REVISION TRANSMITTAL

This sheet transmits Revision 2 to MTB-33-03, which:

LIGHTS - LED TAIL STROBE LIGHT INSTALLATION

MTB-33-03
 Page 1 of 15

Figure 1. Before Modification (Sheet 1)

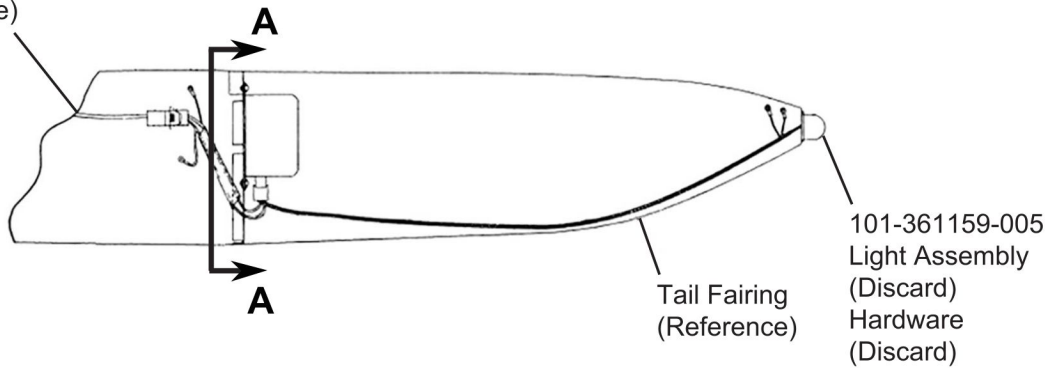
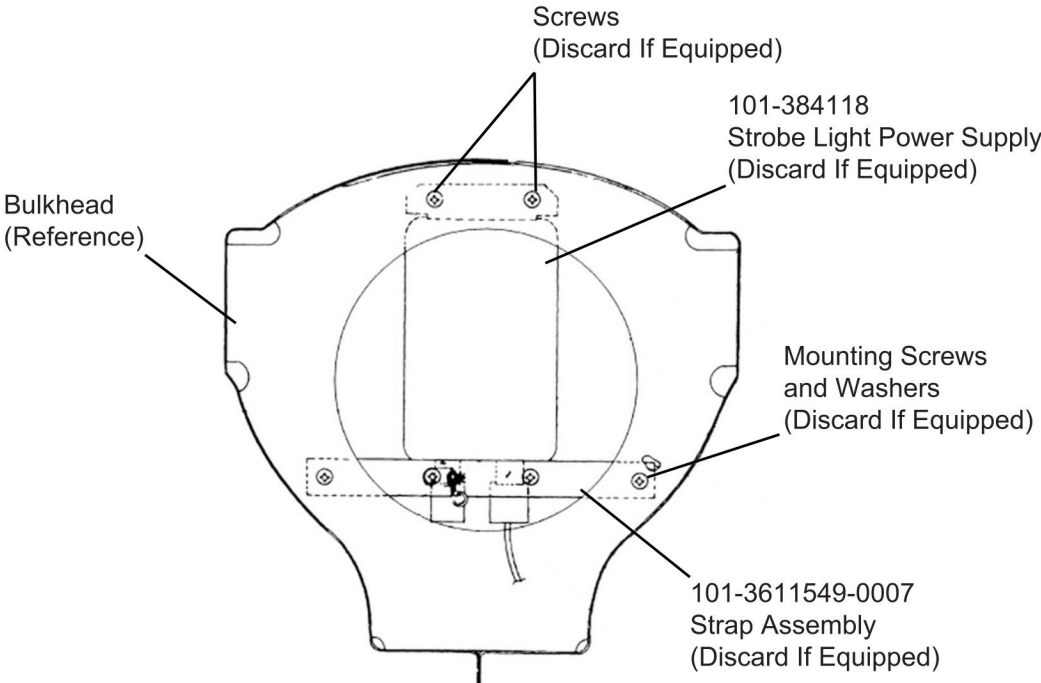
- 3. (Refer to Figure 1, Sheets 1 and 2.) Remove the aft tail strobe light assembly and wiring as follows:

- A. Airplanes equipped with a 101-384118 Strobe Light Power Supply, go to Step 3 C.
- B. Airplanes not equipped with a 101-384118 Strobe Light Power Supply, go to Step 3 F.
- C. Remove and discard the four screws that attach the 101-384118 Strobe Light Power Supply.
- D. Remove and discard the two mounting screws and washers that attach 101-3611549-0007 Strap Assembly to the bulkhead.
- E. Discard the 101-3611549-0007 Strap Assembly.
- F. Remove and discard the hardware that attaches the 101-361159-005 Light Assembly to the tail fairing.
- G. Discard the 101-361159-005 Light Assembly and the associated harness.

Figure 2. Wiring Modifications (Sheet 1)

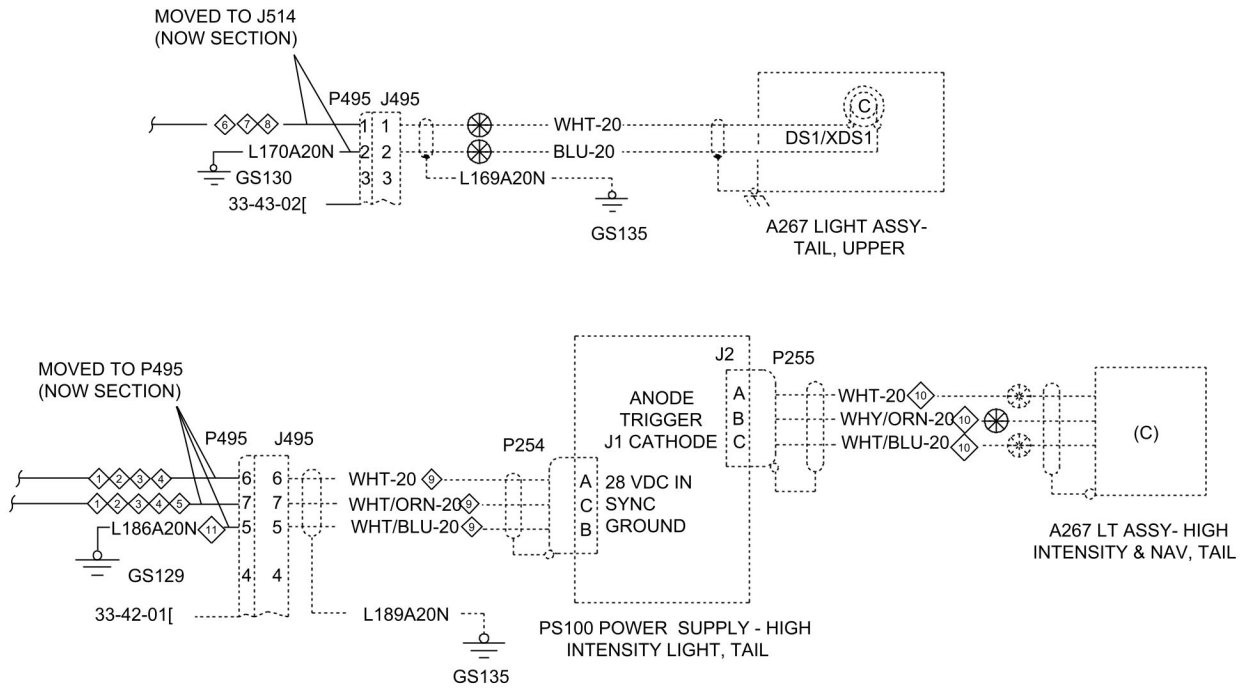
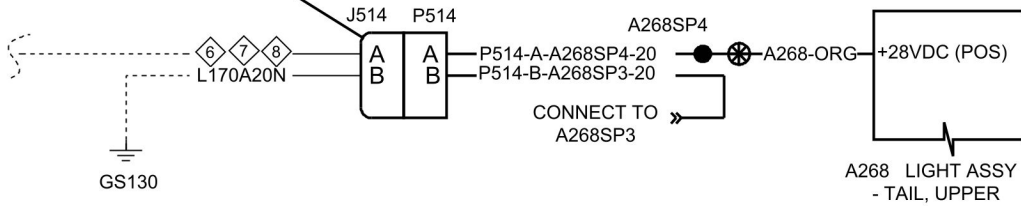
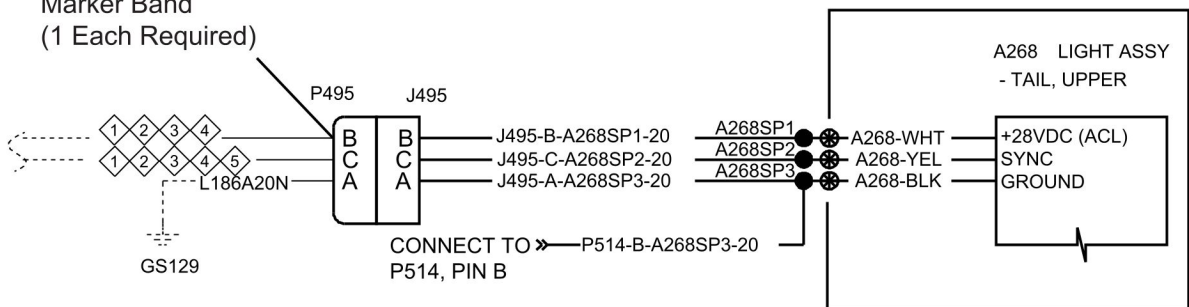
- 4. (Refer to Figure 2, Sheets 1, 2, and 3.) Do the wiring modification to the airplane wiring harness as follows:

- A. Remove and discard the P495 Connector.
- B. Install a SJS840400 Pin Receptacle two M39029/58-364 Contact Pins and two MS27488-16 Sealing Plugs onto the existing airplane wiring harness.
- C. Install a SJS840410 Pin Plug with three M39029/57-358 Sockets and one MS27488-16 Sealing Plug onto the existing airplane wiring harness.
- D. Install and label each connector using one 131741-3 Marker Band onto the airplane wiring harness.

Figure 3. After Modification (Sheet 1)

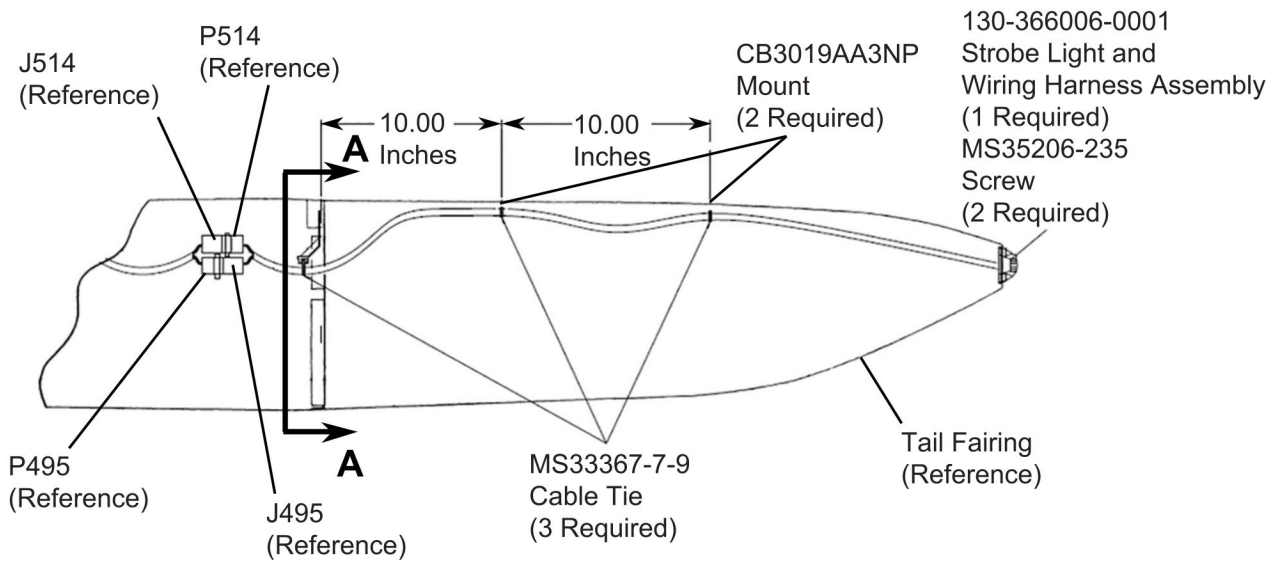
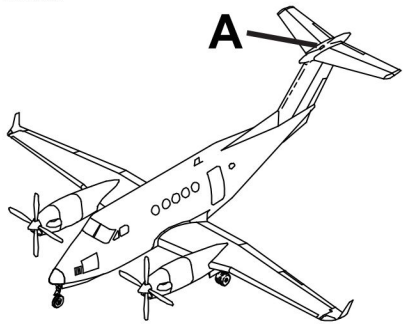
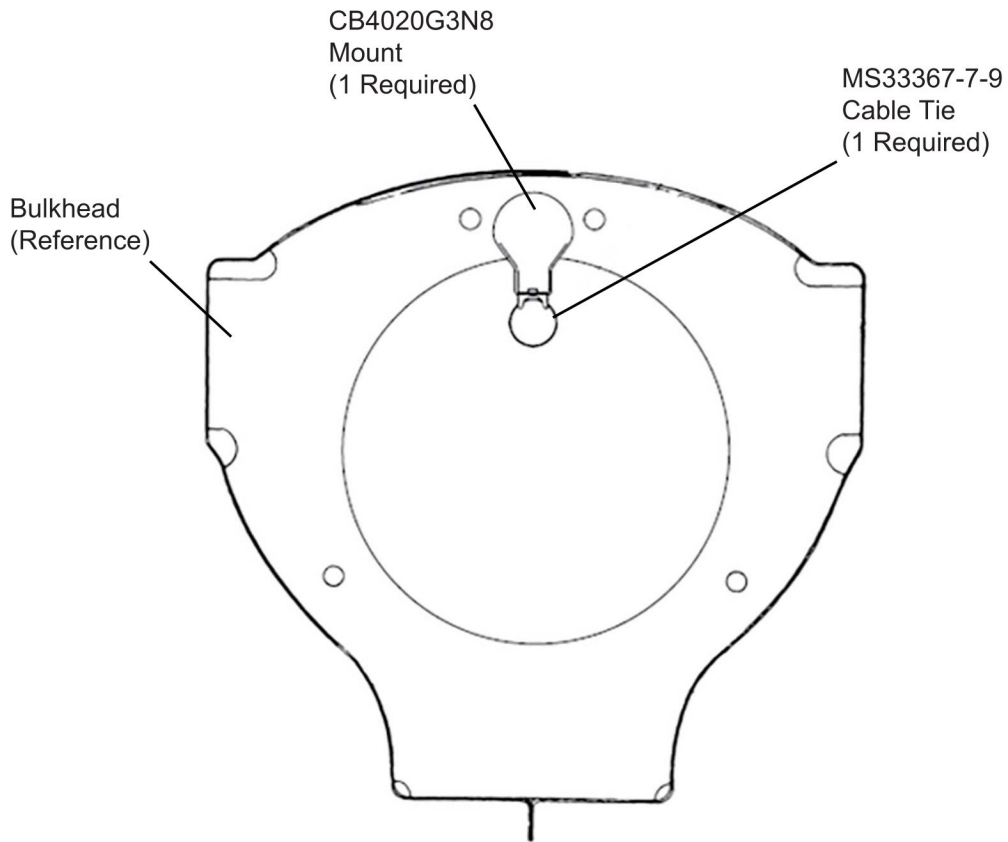
- 5. (Refer to Figure 3, Sheets 1 and 2.) Install the 130-366006-0001 Strobe Light and Wiring Harness Assembly as follows:

- A. Apply EA9309 Adhesive to the two CB3019AA3NP Mounts.
- B. Install the two CB3019AA3NP Mounts onto the upper surface of the tail fairing approximately 10.0 inches from the bulkhead and from each other.
- C. Apply EA9309 Adhesive to the CB4020G3N8 Mount and install the CB4020G3N8 Mount to the forward side of the bulkhead in the tail fairing.
 - (1) Make sure the EA9309 Adhesive has had time to cure.
- D. Install the wiring harness of the 130-366006-0001 Strobe Light and Wiring Harness Assembly from the aft end of the tail fairing.
- E. Electrically bond the 130-366006-0001 Strobe Light and Wiring Harness Assembly to the aft end of the tail fairing.
 - (1) Apply adequate U470638 Sealant between the 130-366006-0001 Strobe Light and Wiring Harness Assembly and tail fairing.
